## Comparison of Approaches for Calculating a Jocassee Dam Failure Frequency

### DRAFT

#### Objective

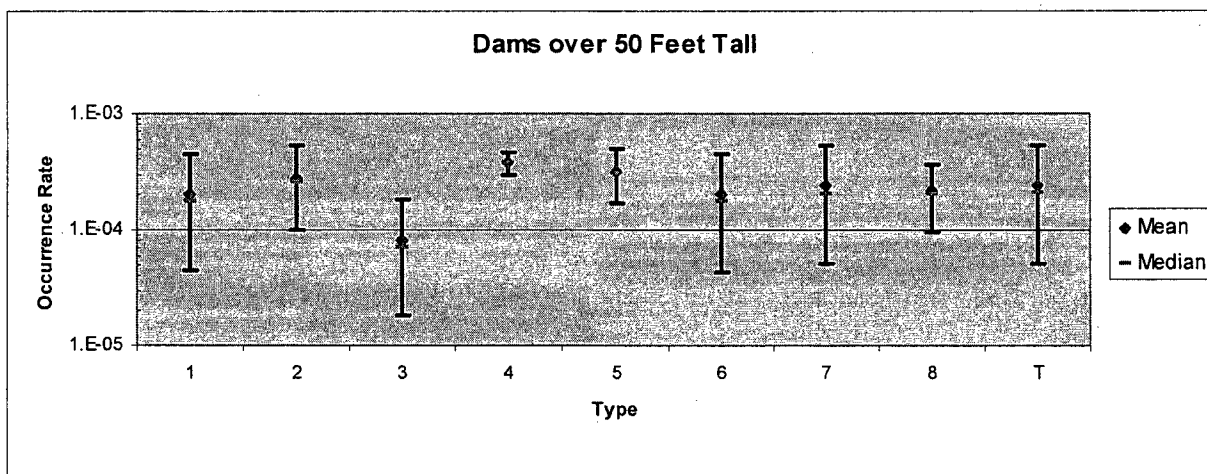
To understand the magnitude of this error for Jocassee, the NRC staff recalculated the Jocassee dam failure frequency using failure data from the National Performance of Dams Program and the dam descriptions and population from the National Inventory of Dams. In order to approach the selection criteria used for NSAC/60, the NRC staff calculation eliminated certain dams from consideration that would affect failure data including those less than 50 feet high due to different construction practices and low head, dams constructed before 1940 due to improved design and construction techniques post-1940, and dams that failed shortly after construction. In doing so, the staff accounted for 34 dam failures (2 rockfill and 32 earthen dams). The corresponding population experience value was 162,569 operating dam-years. The resulting dam failure frequency with this population was  $2 \times 10^{-4}$  failures per dam-year.

The staff notes that any correct correspondence of failed population to total population operating dam-years results in a similar  $>10^{-4}$  magnitude dam failure frequency (e.g., rockfill dam failures to rockfill operating dam-years, earthen dam failures to earthen dam operating dam-years, and gravity dam failures to gravity dam operating dam-years). Similar international dam failure results have been  $2 \times 10^{-4}$  to  $4 \times 10^{-4}$  per dam-year (Baecher, Gregory, M.E. Pate and R. Neuville. "Risk of Dam Failure in Benefit-Cost Analysis." Water Research. 16(3):449-456. 1980).

The NRC estimates of dam failure frequencies by type of dam are 10 to 20 times higher than the estimate in NSAC/60 and by extension, NUREG/CR-5042. Illustrative examples of the dam failure probability results are presented in the below table and figure.
